BLUE BIRD

R08NM

**SUBJECT: RECALL R08NM LIFT ENABLE INTERLOCK
 NONCOMPLIANCE**

Lift Enable Interlock

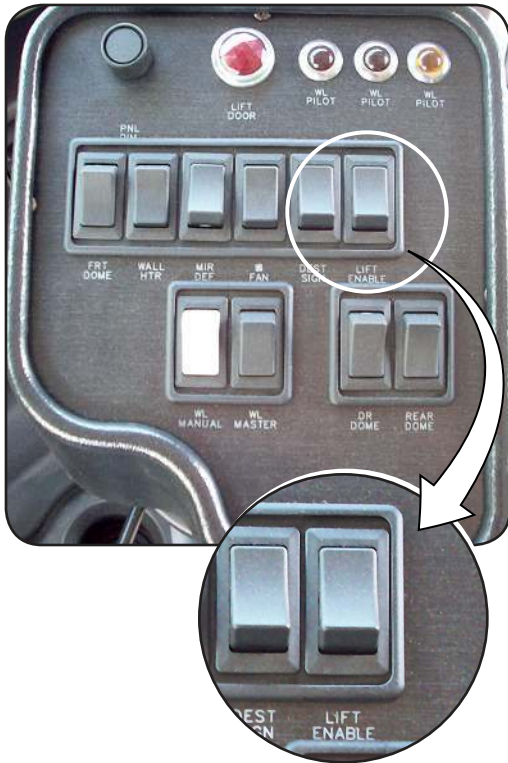
Lift enable switch can render wheelchair lift interlocks inoperative.

Remove lift enable switch, butt splice wires and install blank plug in former switch position.

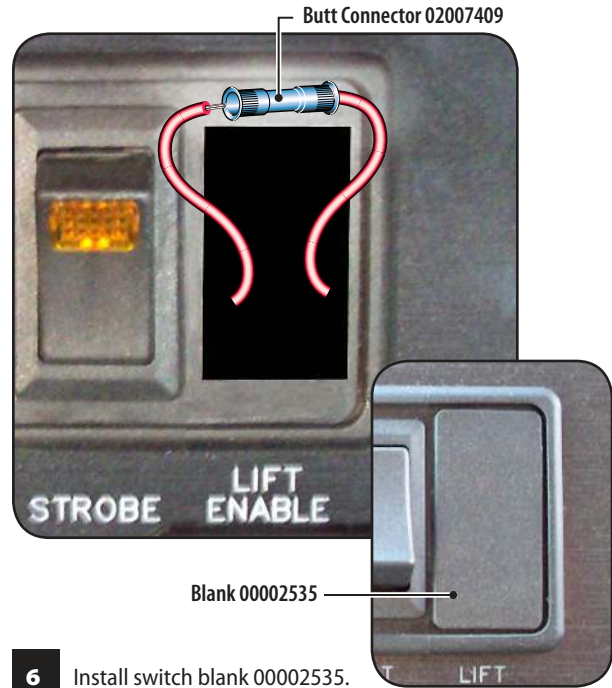
- 4 Cut the two wires as close as possible to electrical connectors,

- 5 Strip wires and install butt connector 02007409 connecting the two wires together. Push completed wiring back inside the panel.
